APPEAL SUMMARY

Appeal ID: 14946	Project Address: 1278 SE Marion St
Hearing Date: 4/12/17	Appellant Name: Todd Iselin
Case No.: B-010	Appellant Phone: 5036561942
Appeal Type: Building	Plans Examiner/Inspector: Peter Drake
Project Type: commercial	Stories: 5 Occupancy: R-2 Construction Type: III
Building/Business Name: The Garthwick	Fire Sprinklers: Yes - throughout
Appeal Involves: Erection of a new structure	LUR or Permit Application No.: 16-195888-CO
Plan Submitted Option: pdf [File 1] [File 2] [File 3] [File 4] [File 5]	Proposed use: multi-family apartment

YELLOW SUBMARINE LLC
THE GARTHWICK
13th AND MARION ST
PORTLAND, OREGON

5TH LEVEL FIRE & LIFE SAFETY PLAN
3/32" = 1'-0"

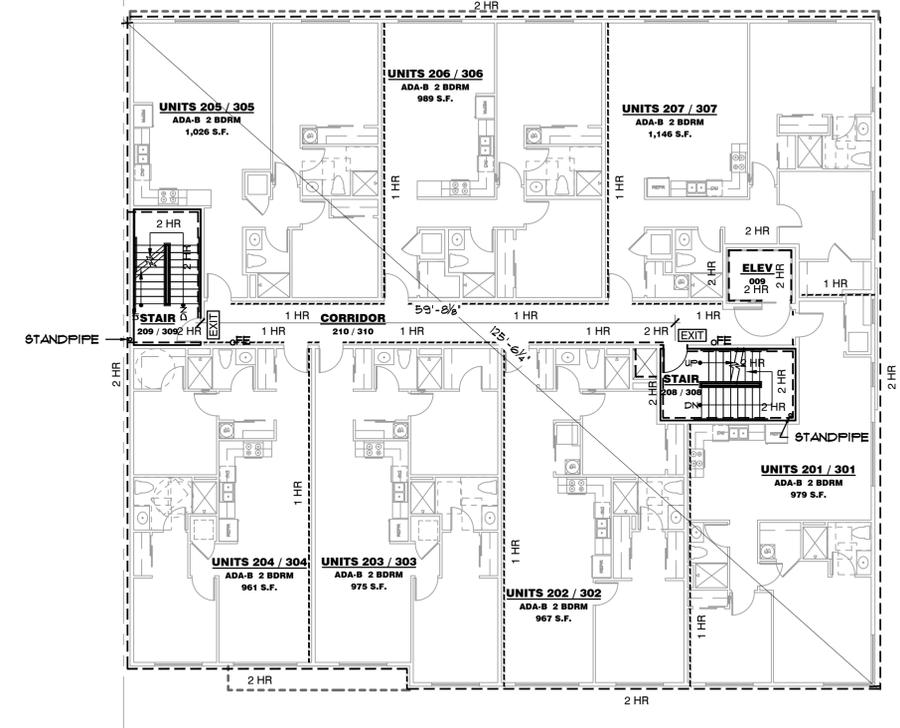
DWELLING UNITS (1) TYPE A MAIN LEVEL ONE BEDROOM UNIT
(1) TYPE A MAIN LEVEL TWO BEDROOM UNIT
ALL LEVEL 2, 3 & 4 UNITS - TYPE B
LEVEL 5 UNIT NOT ACCESSIBLE (NO ELEVATOR SERVICE)

1. Omission of accessible route / elevator to single unit on 5th floor: Denied. Proposal does not provide equivalent access.

FIFTH LEVEL FLOOR PLAN & ROOF PLANS

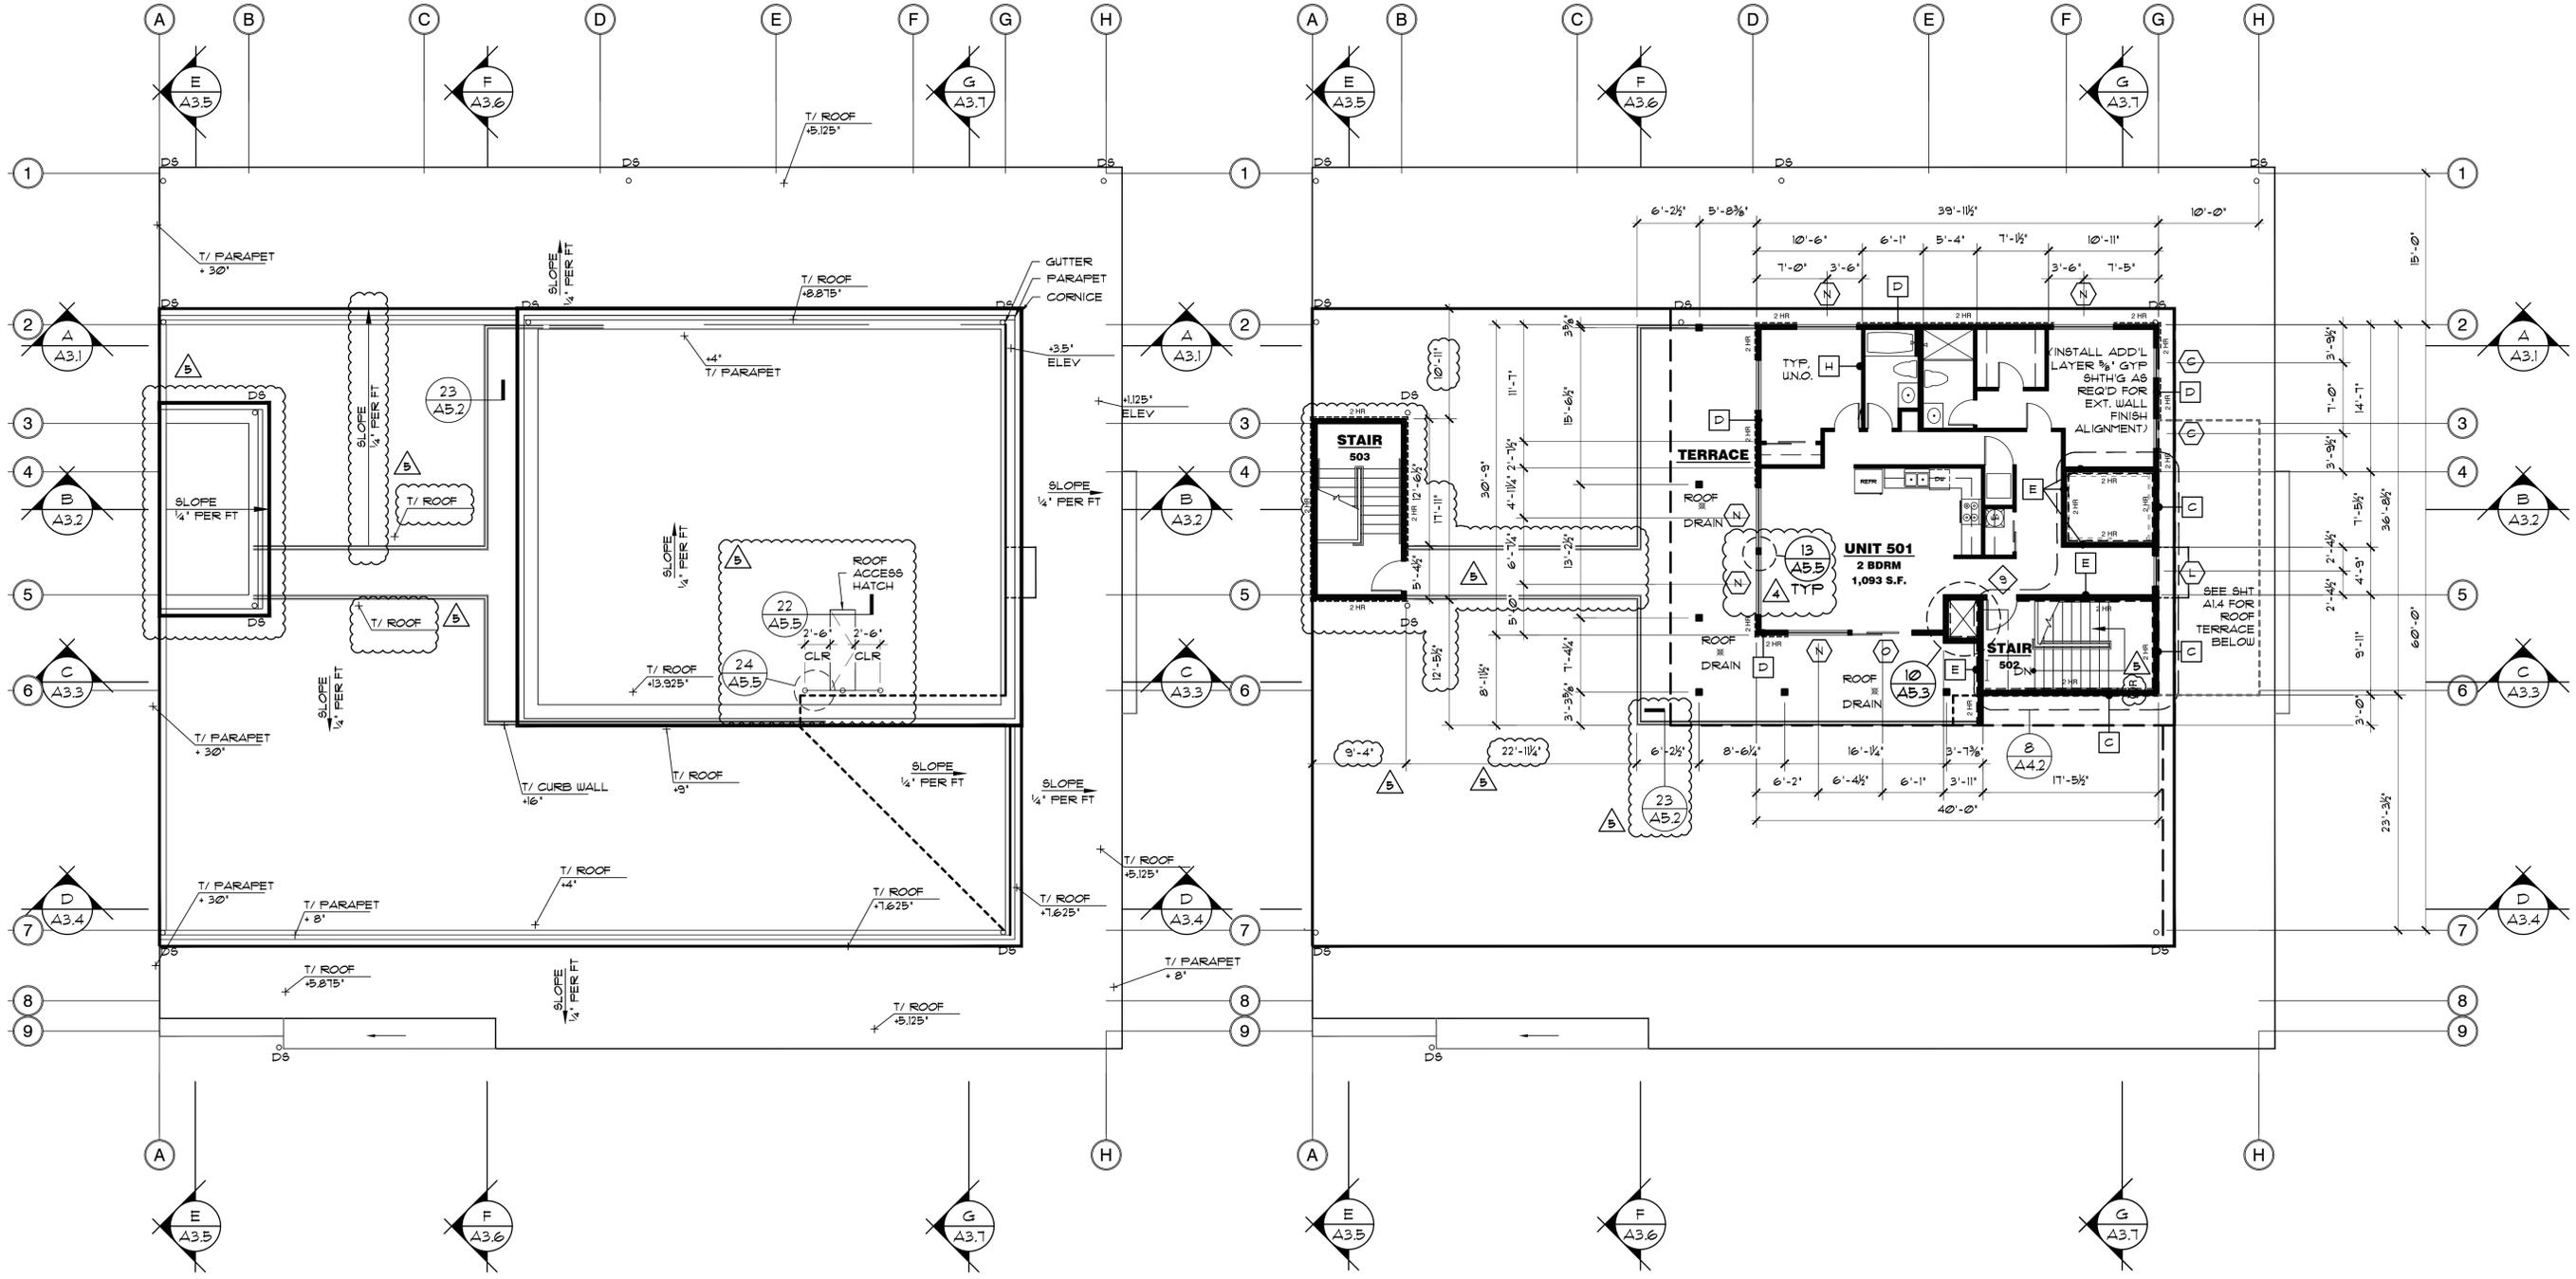
Code Section	1007.2.1/ 1007.4
Requires	<p>1007.2.1 requires an elevator complying with section 1007.4 in buildings where a required accessible floor is four or more stories above or below the level of exit discharge.</p> <p>1104.4 requires at least one accessible route connecting each story and mezzanine in multi story buildings.</p>
Proposed Design	<p>The proposed design does not have an accessible unit on the 5th floor and is not served by elevator service. The 5th floor has a single 1,170 s.f., two bedroom apartment unit.</p> <p>The fifth floor unit is not proposed to be accessible, since there are 23 accessible units (24 total) within the planned building. The building proposed is fully sprinklered and has two means of emergency egress from each level.</p> <p>A single Type A unit is allowed per 1107.6.2.1.1,. Two Type A units are proposed on the ground level to provide both a 1 bedroom and a 2 bedroom Type A unit. There are an additional 21 Type B units on floors 1-4.</p>

Reason for alternative	<p>1107.7 allows for reductions in the numbers of Type A and Type B units and does not require accessibility on floors that are not served by an elevator.</p> <p>The fifth floor has no common facilities and a common outdoor space is provided on the fourth floor that is served by an elevator.</p> <p>If there is no "required" accessibility to the 5th floor than elevator service to this floor is not necessary.</p>

The increased cost for the elevator to serve this 5th floor is disproportional. An alternate to create (4) multistory units as allowed per 1107.7.2 at the fourth and fifth floor was explored to not have the 5th floor accessible, but the Owner did not feel these were marketable units.
